**From:** Winslow, Frank (ECY)  
**Sent:** Friday, June 16, 2023 11:58 AM  
**To:** 'Lisa Thompson'  
**Cc:** Rake, Brandon; Riley Conkin; Suzy Stumpf  
**Subject:** RE: Results Summary and Recommendation for Block 10 Site DPE System (VCP Project ID: XN0032)  
**Attachments:** ENGINEERING ISSUE\_SOIL VAPOR EXTRACTION.PDF; B10\_Figures\_Tables\_Chart.pdf

Ecology has received your request for concurrence for cessation of operation of the Block 10 NE DPE and SVE and system. This email focuses on the SVE system, as that follows the discussion within our April 19, 2023 intake meeting and rebound testing had been proposed to support potential shut-off of the SVE system. Shut off of the DPE system as a whole also pertains to whether or not cleanup of groundwater is sufficient. As further discussed below, Ecology's opinion on the sufficiency of groundwater cleanup must await submittal of a cleanup action completion report and our preparation of an opinion letter.

Figure 5. Parameter fit to SVE operations and periods of rebound

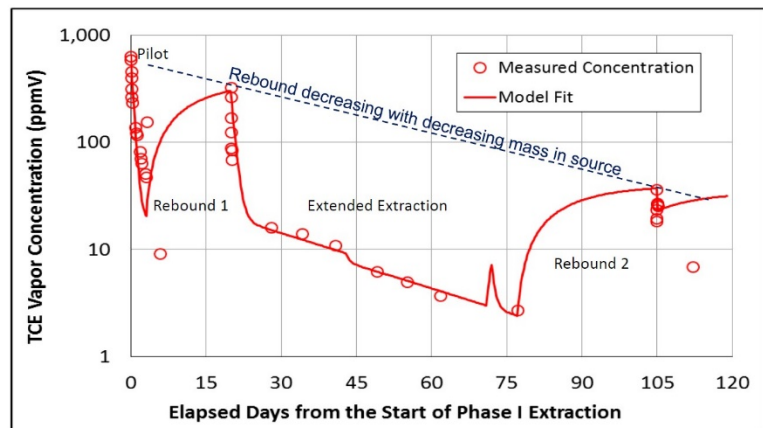
*Consider again the example of the perched water lens; the extracted vapor concentrations may fall rapidly during initial SVE operations as contaminants are removed in soil gas from the more permeable zones, but once the SVE operations cease, contaminant vapor concentrations build slowly back to the initial condition by diffusion from the clay and water lens as only a small fraction of the initial contaminant mass was removed.*

The following chart illustrates this phenomena:

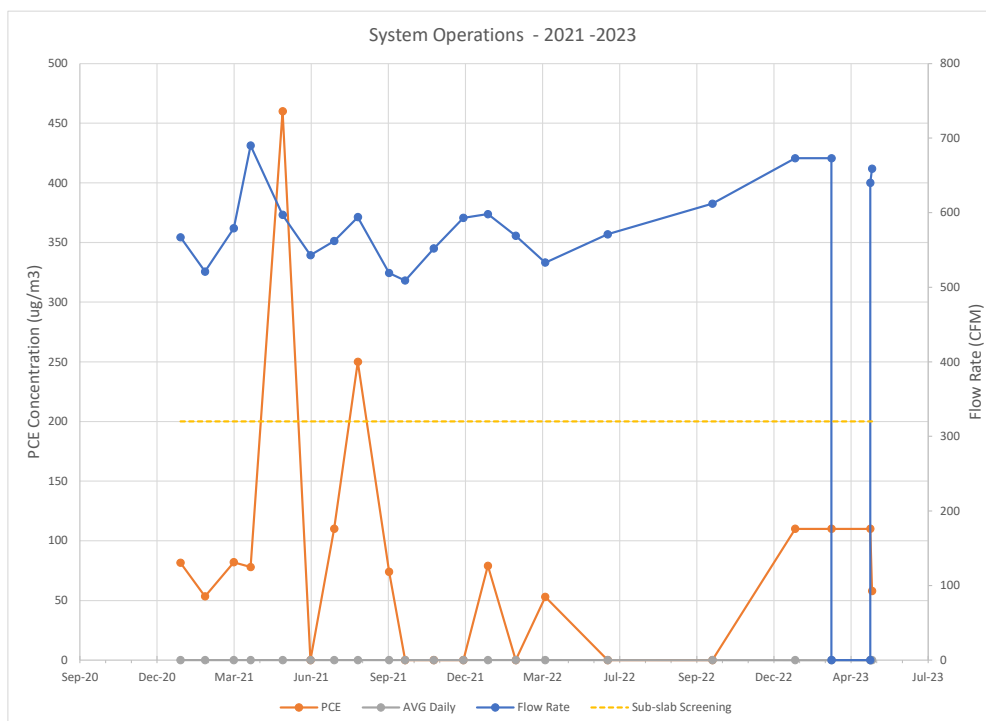
In general, assessment of continued SVE performance pertains to review of the rebound data. The overall system performance illustrated in Chart 1, Cumulative Vapor Phase PCE Removal does not present data in a sufficiently granular fashion to assess rebound. Therefore, Ecology prepared the following chart to exam the recent data more closely. Ecology notes that PCE in air results correlate well with average daily mass removal rates but PCE concentrations may be more easy to conceptualize.

The following conclusions can be made from this chart.

- The PCE concentration following the system shutdown in March-April dropped slightly. This suggests rebound was not occurring.
- The PCE in air concentrations have been fairly noisy; however, highest concentrations dropped between 2021 and 2023.
- The last sub-slab screening level (unrestricted) exceedances for PCE in discharge air were during two events during 2021.

Based on this analysis, Ecology concurs that the relative benefits of continued operation of the SVE system appear to be low. The shallow groundwater system has reportedly been drying up; therefore, the soil-to-groundwater pathway appears to likely be less viable. However, review of groundwater data were not part of Ecology's analysis and conclusions regarding the soil-to-groundwater pathway being incomplete are not being made by Ecology at this time. That conclusion would require a thorough analysis of available hydrogeological, contaminant, and operational data. Therefore, Ecology suggests the following:

The decision to discontinue operation of the SVE system appears to be defensible, provided that operation of the SSDS continues. Continued operation of the SSDS is considered advisable at this time, regardless of the SSDS sampling results.

Since Ecology has not yet provided our opinion regarding the soil-to-groundwater pathway, Ecology suggests that the SVE system not be decommissioned until following that opinion. Ecology anticipates providing our opinion following submittal of a Cleanup Action Completion Report for the Site.
